Access Compliance Report

Public Rights-of-Way

(Curb Ramps)

Intersection ID: 6670	Main Street: BELMAR_PLACE_RD	Cross Street: ERNIE_DR	Location: SE
ADA ID: BB852ADAFEBE	Ramp Type: PerpDiag	Initial Pass/Fail: Fail	Overall Compliance: No
Severity Score: 21.25			
Codes/Mitigation Info/Possible Solution		Field Measurements/Component Compliance

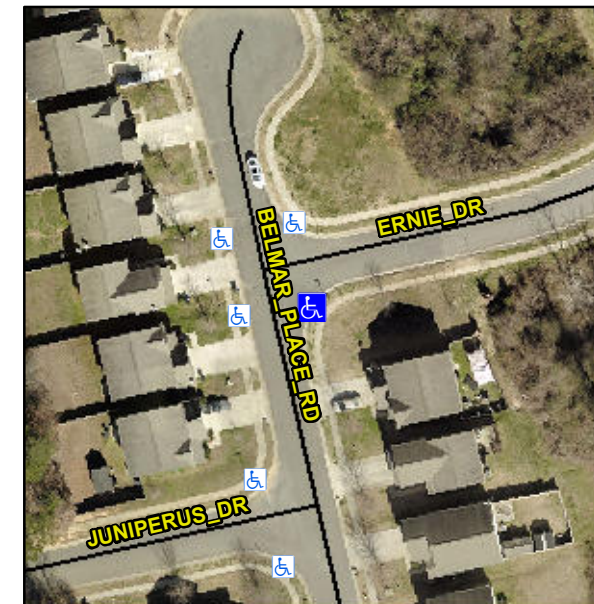
R304.5.1, R304.5.3

Compliance	Description	Data	Compliance	Description	Data
N/A	Ramp Length (in)	50.5	Yes	Ramp Slope (%)	5.2
No	Ramp Width (in)	46.0	No	Ramp XSlope (%)	6.8
N/A	Flare Type LT	N/A	N/A	Flare Type RT	N/A
N/A	Flare Slope LT (%)	N/A	N/A	Flare Slope RT (%)	N/A
N/A	Flare Traversable LT?	N/A	N/A	Flare Traversable RT?	N/A
N/A	Landing Length (in)	N/A	N/A	DWS Provided?	N/A
N/A	Landing Width (in)	N/A	N/A	DWS Contrast?	N/A
N/A	Landing Slope (%)	N/A	N/A	DWS Length (in)	N/A
N/A	Landing X Slope (%)	N/A	N/A	DWS Full Width?	N/A
N/A	Landing Curb? (Y/N)	N/A	N/A	DWS Offset (in)	N/A
N/A	Shared Landing?	N/A			
N/A	Gutter Ponding?	N/A	N/A	Gutter Slope (%)	N/A
N/A	Gutter Lip Ht (in)	N/A	N/A	Gutter X Slope (%)	N/A
N/A	Painted X Walk1?	No	N/A	Painted X Walk2?	No
	X Walk 1 Direction	To N		X Walk 2 Direction	To W
N/A	X Walk 1 Width (in)	N/A	N/A	X Walk 2 Width (in)	N/A
	X Walk 1 Slope (%)	4.2		X Walk 2 Slope (%)	5.5
	X Walk 1 X Slope (%)	6.0		X Walk 2 X Slope (%)	2.7

Remove & Replace Curb Ramp With Two New Directional Ramps or Equivalent.
